ASUS FX506LU N18E-G0 Block Diagram

Model
FX506LU

CHANGE LIST

DOC NO.	PROJECT MODEL :	BKLG/BKLN	APPROVED BY:	DATE:	2018/01/17
	PART NUMBER:		DRAWING BY:	REVISION:	1A

eDP

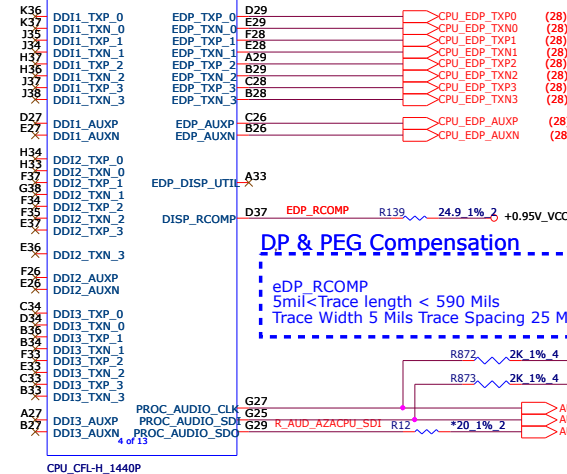
ADD R872,R873 2kohm pull down for desable audio form CPU....Tommy_0924
